HISTORIC LANDMARK COMMISSION
STAFF REPORT

McIntyre House Addition
PLNHLC2014-00424
259 E 7Th Avenue
August 7, 2014

Proposed Connecting Mudroom
and Stair Additions

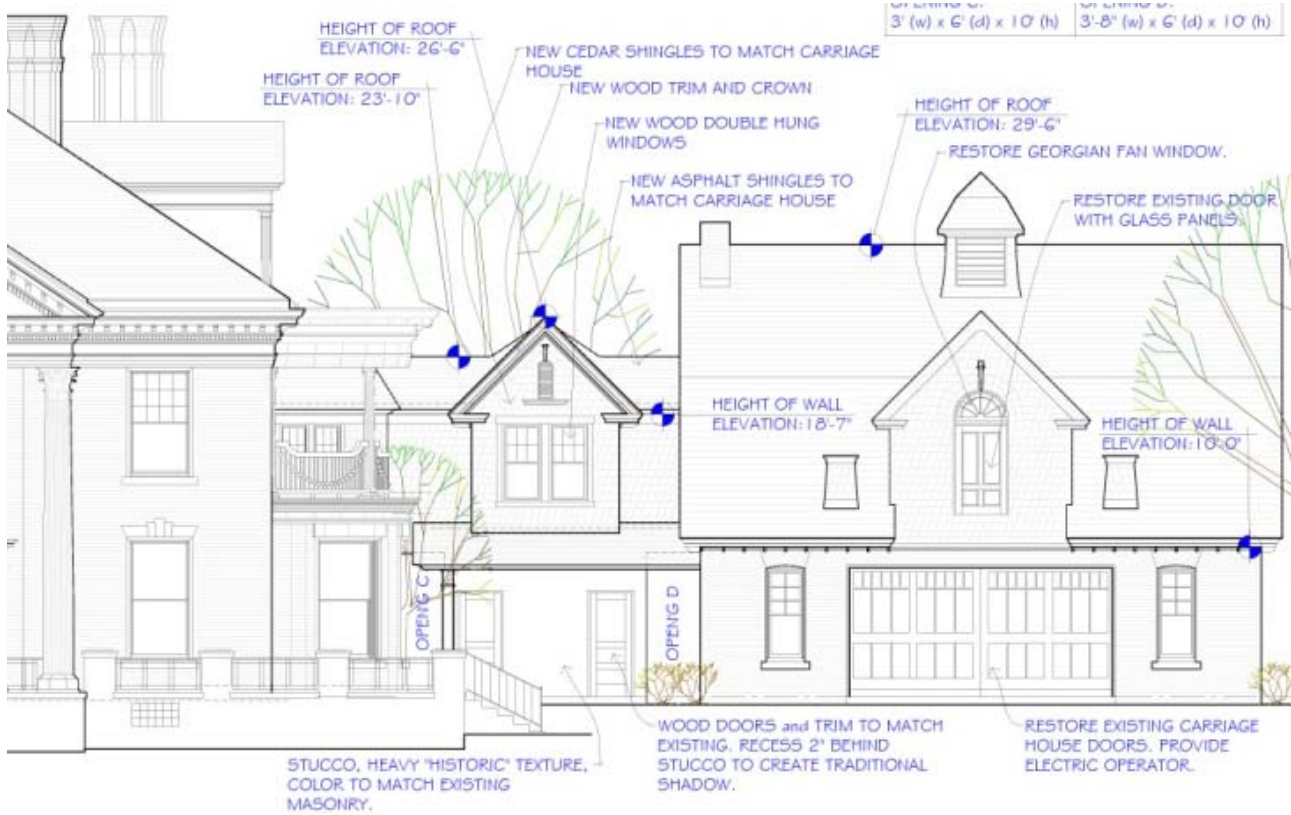
The stairwell addition will obstruct the historic original carriage house as a whole, blocking the west view of the unique two and a half story carriage house, along with the historic windows and door that can currently be seen from B Street. The applicant has been mindful of reducing the amount of changes that can affect the exterior of the buildings by avoiding a direct linkage of the stairwell to the carriage house, instead the stairwell is set back and a narrower hallway is used to connect to the carriage house, allowing for the preservation of the existing windows and door. The proposed addition is sited to the rear of the principal structure, which minimizes the visual impact on the principal structure, but not the accessory structure. The materials used for the stairwell include stucco on the ground floor and cedar shingles on the top floor, which are similar to the carriage house. The windows will be double hung, wood windows that match the existing windows on the principal structure and the carriage house.

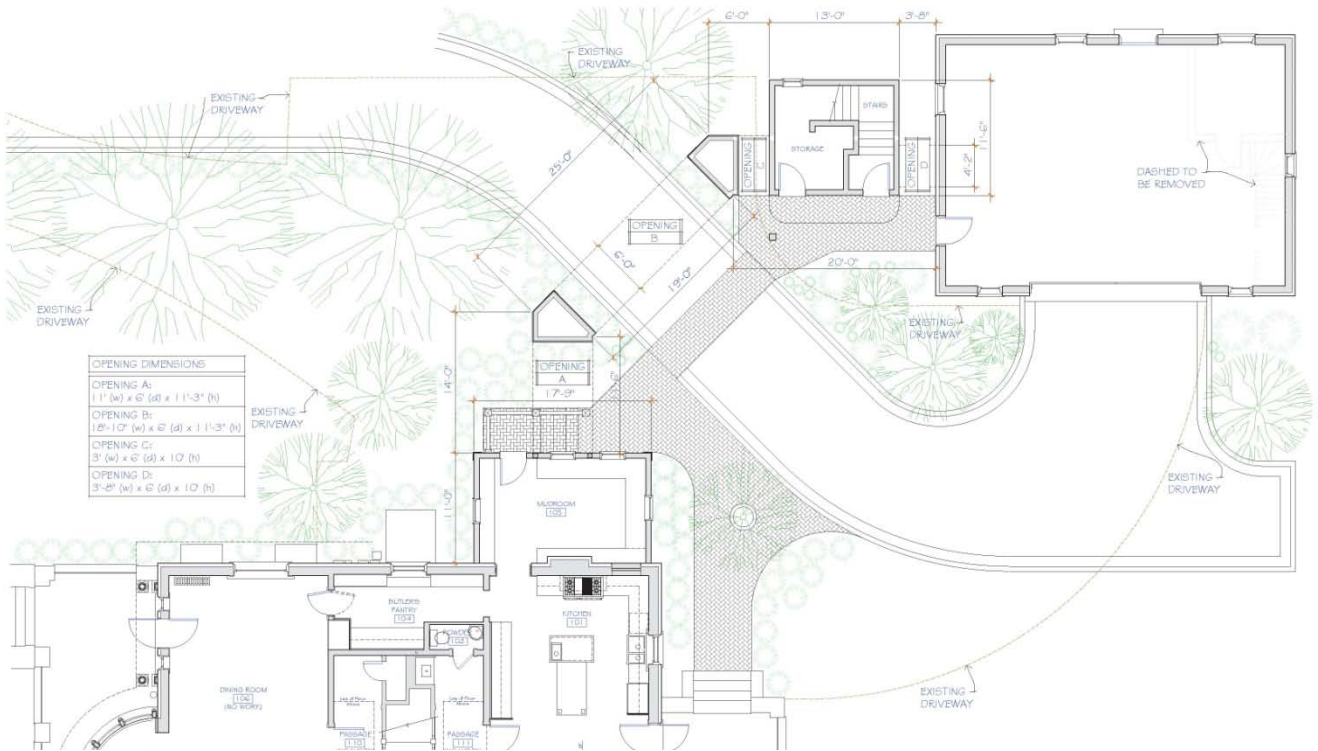
The reconfiguration of the driveway will not affect the historic character of the property. The driveway will maintain the same entrance and will be paved with concrete, which is an appropriate material. The footprint of the proposed concrete driveway in comparison to the existing driving will be less. The excess concrete will be removed and will be re-established with landscaping. The driveway reconfiguration will require two large trees to be removed. However, the applicant will be planting new trees and landscaping along the new proposed driveway. The driveway reconfiguration will not remove any historic materials or alterations of features.

WEST ELEVATION
 SCALE: 1/4" = 1'-0"

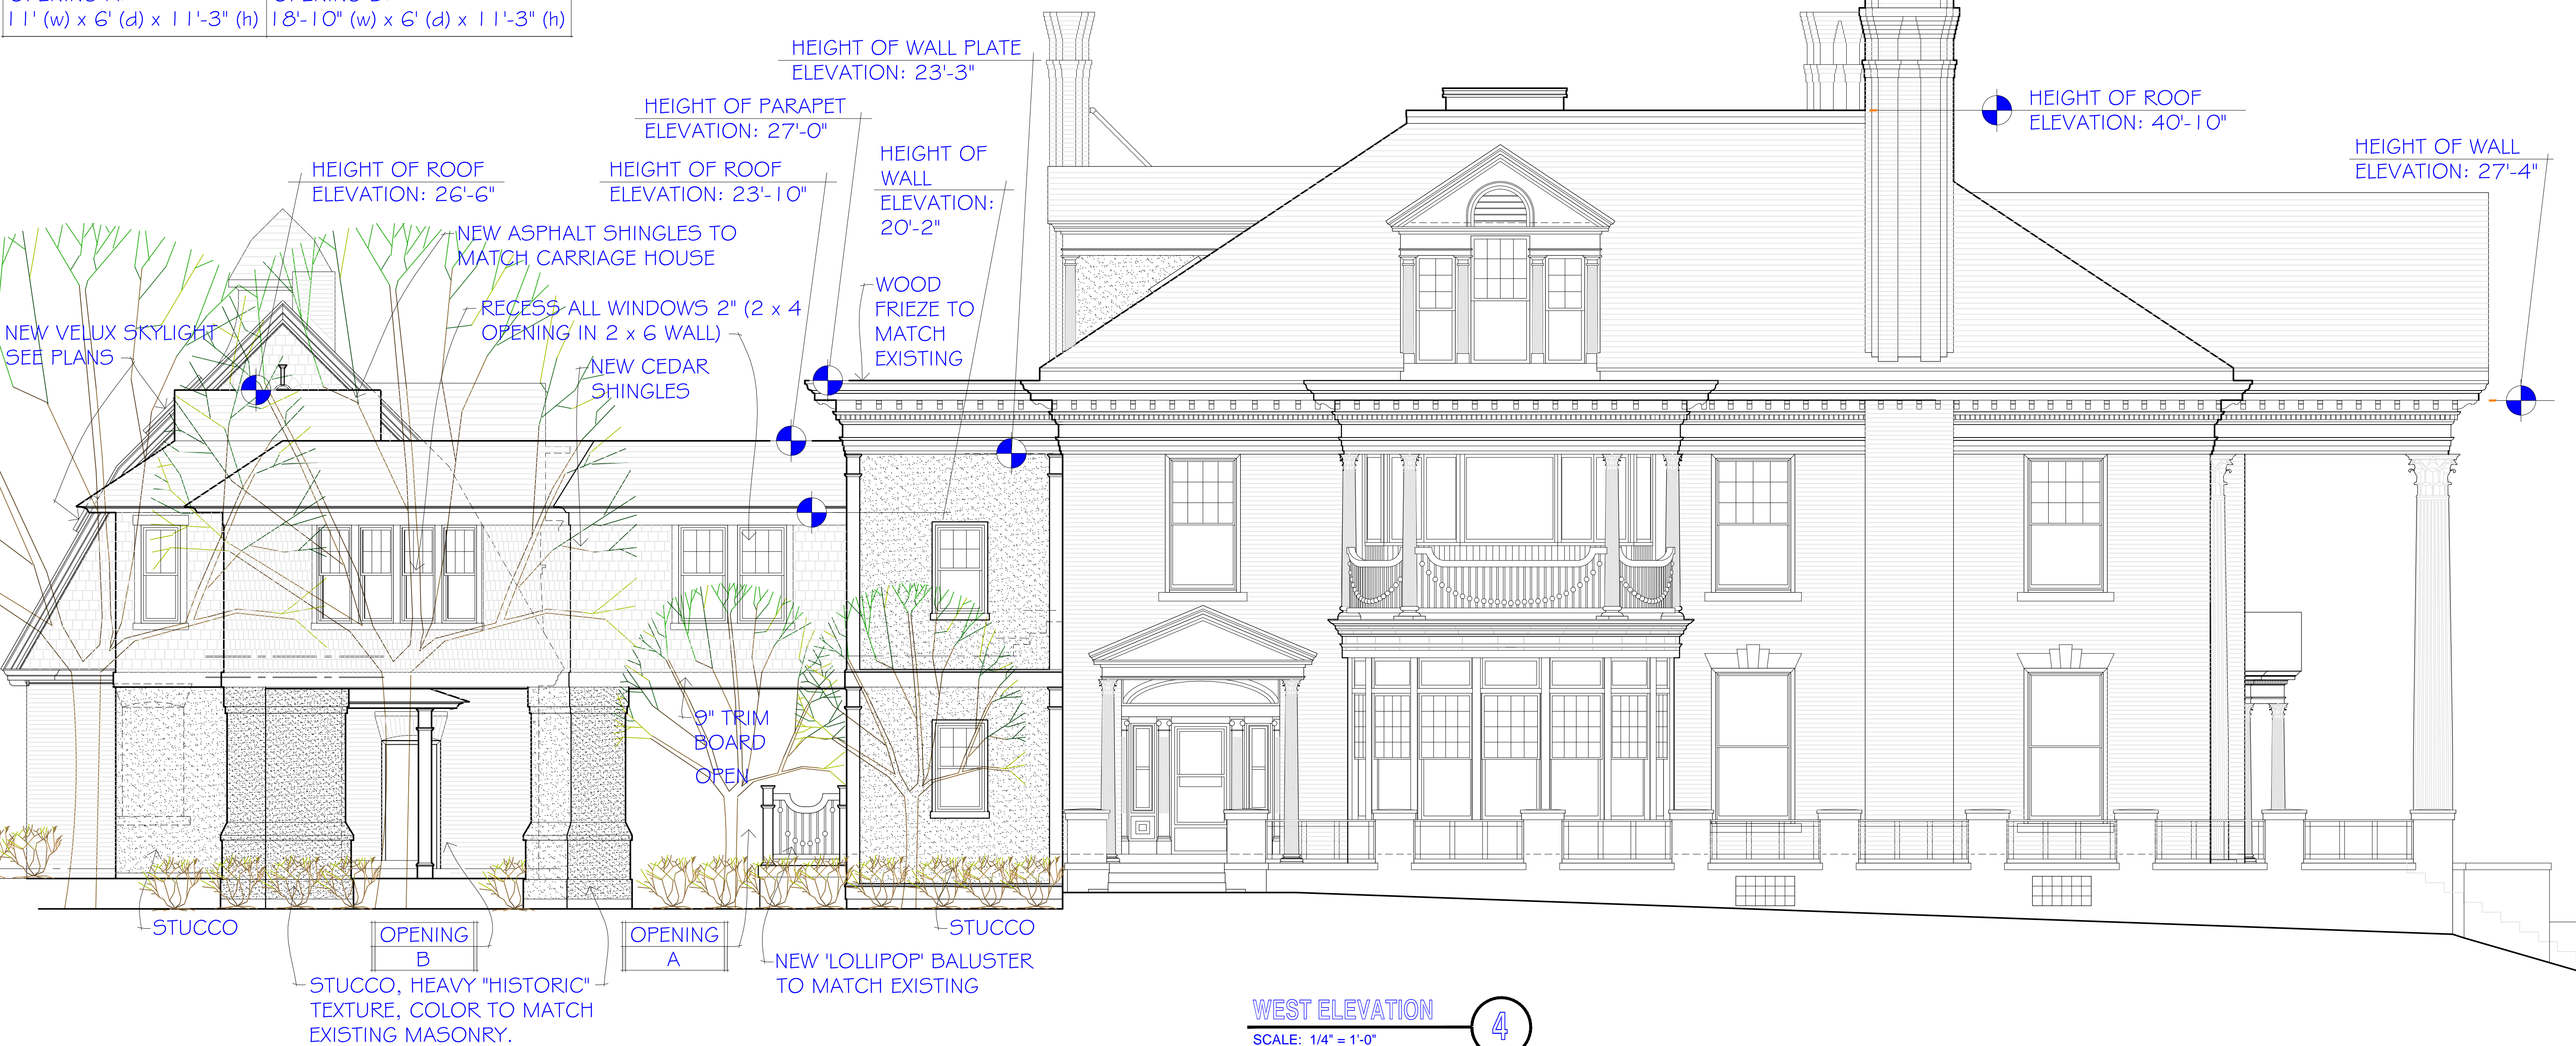
The original buildings on site are both rectangular in mass and have a vertical emphasis. The proposed walkway would add a horizontal emphasis and the massing would significantly alter the established massing of the historic structures, from two separate rectangular masses to one large mass. The separation of the principal structure and the accessory structure is a significant historical and architectural feature of the property. The proposal to connect the two structures will destroy this historical and architectural feature. The proposed scale and size of the walkway would not preserve the massing of the two historic buildings and the connection of the principal and accessory structures would hinder one's ability to interpret the historic character of the building. The elevated walkway horizontally overpowers the site and covers the carriage house, especially from the west view. The connection will change the defining spaces of the

principal structure and the accessory structure. The horizontal mass of the walkway will remove the defining spaces between the structures and the new mudroom addition will not be physically and visually subordinate to the historic building as the walkway will dominate the view from the B Street.

The proposed stairwell will sit directly west of the carriage house and will obstruct the majority of the view of the west façade of the carriage house from B Street. The stairwell addition will dominate the view from B Street since it will cover the majority of the carriage house. Very few carriage houses in Salt Lake City are still intact today and the presence of a separated accessory structure and principal structure is an important historical and architectural feature, the addition is not physically and visually subordinate to the historic buildings on site.

Finding: This standard is not met. The mudroom addition alone meets this standard. However, the project as a whole does not meet this standard. The design and massing of the addition to connect the main house with the carriage house significantly changes the character of the property. The proposed walkway and stairwell additions will dominate the view from B Street, covering the historic carriage house.
